- 3. Questa Woods Subdivision Unrein Addition
KPB File 2022-159**

KPB File 2022-159
T 01N R 01W SEC 23
Bear Creek

ITEM 3 – QUESTA WOODS SUBDIVISION UNREIN ADDITION

STAFF REPORT

PLAT OF UNREIN SUBDIVISION

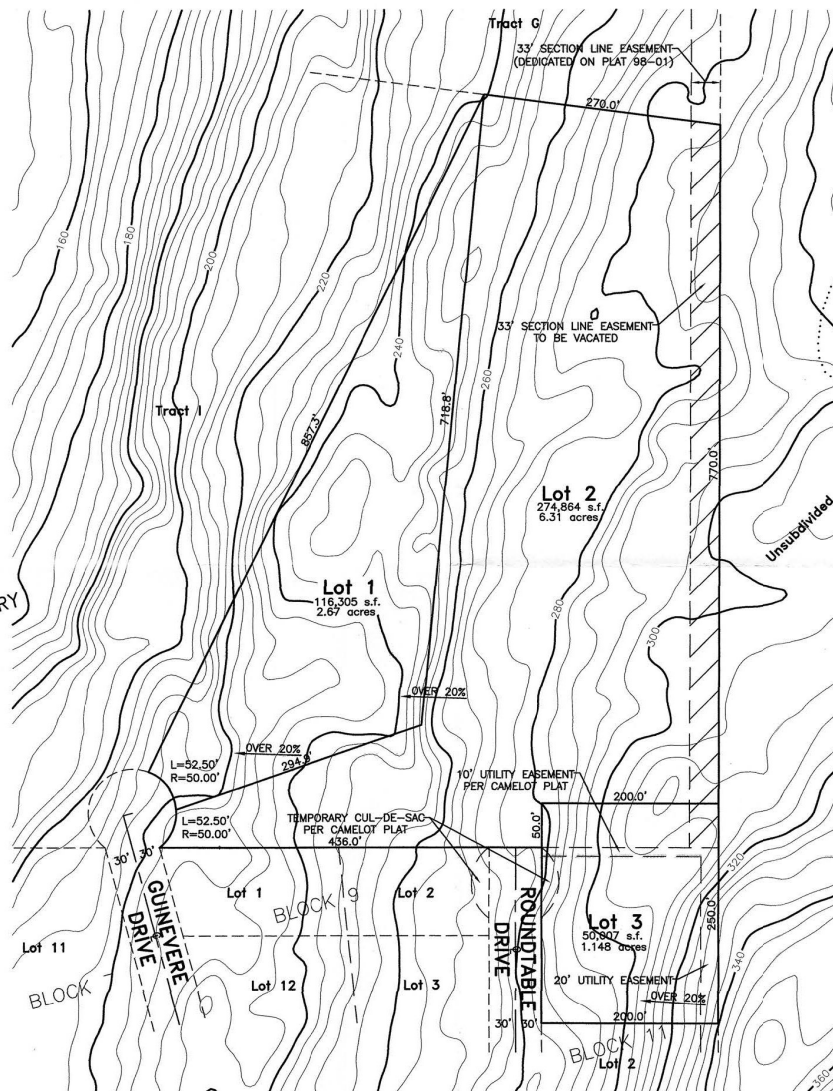
Staff recommendation: Include the KPB File number. Update the file name as discussed with staff. Update the owners' name, "James Simeon".

Staff recommendation: Some information is cut off such as Chugach Forest label. Instead of Seward Corp Boundary update to Seward City Limits. Make sure there are no overstrikes on information.

- G. The status of adjacent lands within 100 feet of the proposed subdivision boundary or the land status across from any dedicated rights-of-way that adjoin the proposed subdivision boundary, including names of subdivisions, lot lines, block numbers, lot numbers, rights-of-way; or an indication that the adjacent land is not subdivided;
Staff recommendation: *Parent plat information is not requested if from the same parent plat listed within the title block. As there are more than one subdivision associated with this plat, provide the recording number for the neighboring lots. The block label for Lot 11 currently has an overstrike, make sure visible with final. The lot south of proposed Lot 3 needs updated from 2 to 3.*

- J. Block and lot numbering per KPB 20.60.140, approximate dimensions and total numbers of proposed lots;
Staff recommendation: *Staff requests the lot numbers be revised to incorporate a former lot number within the new number. Example: 1A, H1, H2. If the lot does not contain a block label it will not be carried over. This is not a requirement but if the owners wish it to be part of the new legal a label will be required.*

- N. Apparent encroachments, with a statement indicating how the encroachments will be resolved prior to final plat approval;
Staff recommendation: *House on Lot 3 appears to be in utility easement. No petition to vacate has been received.*

Staff recommendation: *Plat notes are required as well as depiction or detail drawing.*

Staff recommendation: Plat notes will need to be added that note which lot the note pertains, comply with 20.40.

Staff recommendation: The certificate of ownership shall be done in the plural, correct the spelling of James Simeon's name, provide Leann's middle initial as this is how title was taken. The signature lines should indicate which former lots they are signing on behalf of. Additional notary space may be required. Correct as the current notary is a combination of acknowledgement and jurat. Comply with 20.60.190.
